SUBJECT: Approval of Watermaster Response Report to LPV Technical Advisory Committee Recommendation Report Regarding Basin Optimization Yield Study Numerical Modeling Results [LPV Watermaster] – (New Item)

Re: Recommendation Report – Las Posas Valley Basin, Basin Optimization Yield Study Numerical Modeling Results

Re: Response Report to TAC Recommendation Report – Las Posas Valley Basin, Basin Optimization Yield Study Numerical Modeling Results

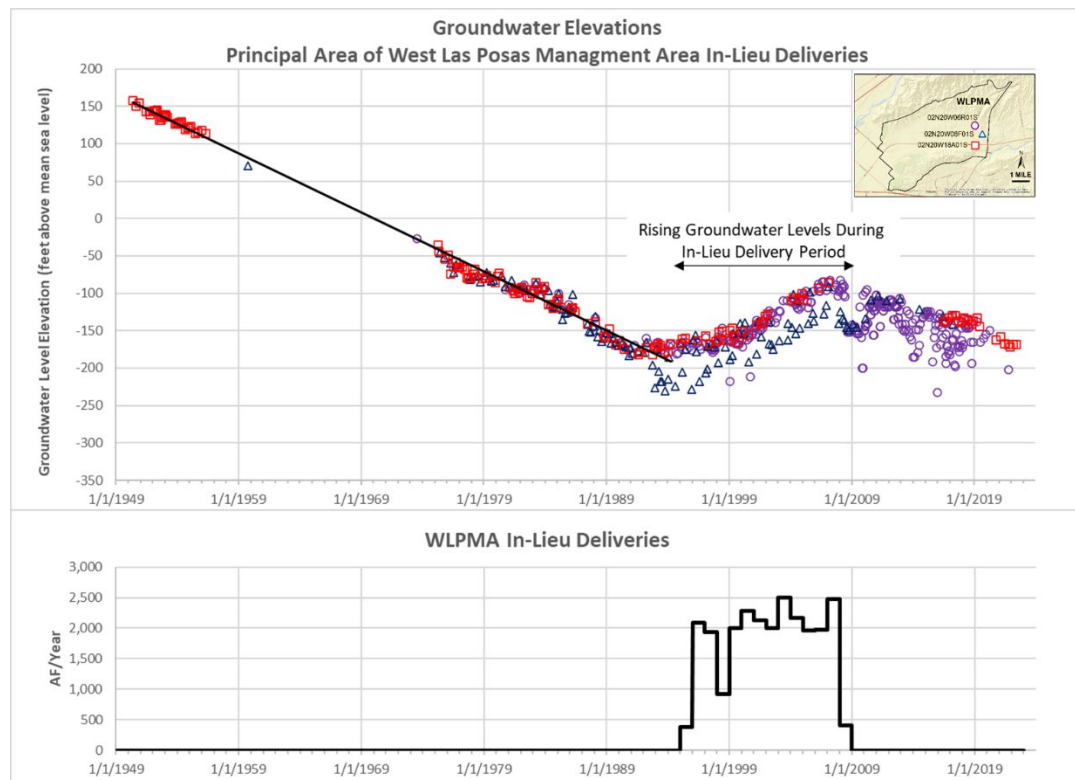
The West Las Posas Management Area (WLPMA) numerical model appears to significantly overestimate the amount of groundwater exchange between WLPMA and the East Las Posas Management Area (ELPMA). More than half of the volume of the simulated with-project in-lieu deliveries to the WLPMA were accommodated by a simulated change in flow between the management areas, which is inconsistent with the conceptual model of the boundary between the WLPMA and ELPMA. This suggests that the model may significantly underestimate the benefits of in-lieu deliveries to the area of the WLPMA to which the related project targeted. It also suggests that the benefits of implementing the project with the simulated volume of in-lieu water delivery may be greater than those simulated. As a result, the actual volume of in-lieu deliveries required to prevent water level minimum threshold exceedances in the WLPMA may be lower than that simulated in the with-project model scenario.

Include in the BOY Study report a detailed explanation of the differences between the baseline model results and the conceptual model at the boundary between the management areas. Also include descriptions of the simulated change in flow across the boundary in the simulation with an explanation of the potential differences between simulated and actual with-project conditions.

The representation of the management area boundary in the WLPMA model allows flow across this boundary and the baseline model scenario simulation indicates flow from the ELPMA to the WLPMA. In the with-project scenario simulation this flow direction reverses and water flows from WLPMA to the ELPMA. The difference in the volumes of flow between the baseline and with-project simulations is 1,033 acre-feet per year (AFY), which is 58 percent of the annual in-lieu delivery volume (1,764 AFY) simulated for the WLPMA with-project scenario.

Historical data demonstrates that a similar magnitude of in-lieu deliveries to WLPMA between 1996 and 2008 resulted in groundwater elevation increases of approximately 90 feet, as shown in the charts above.

The simulated change in groundwater elevations in wells near the WLPMA in-lieu project is much less than the historical observations. The four wells near the project showed simulated average groundwater elevation increases of around 7 to 17 feet compared to baseline simulated elevations. This comparison reinforces the observation that the model simulates WLPMA in-lieu deliveries leaving the management area across what is agreed to be a no-flow boundary. As a result, the simulated in-lieu deliveries likely exceed the volume necessary to achieve and maintain sustainable conditions in the WLPMA.

Watermaster agrees with TAC's recommendations to include these explanations and descriptions in the BOY Study report.
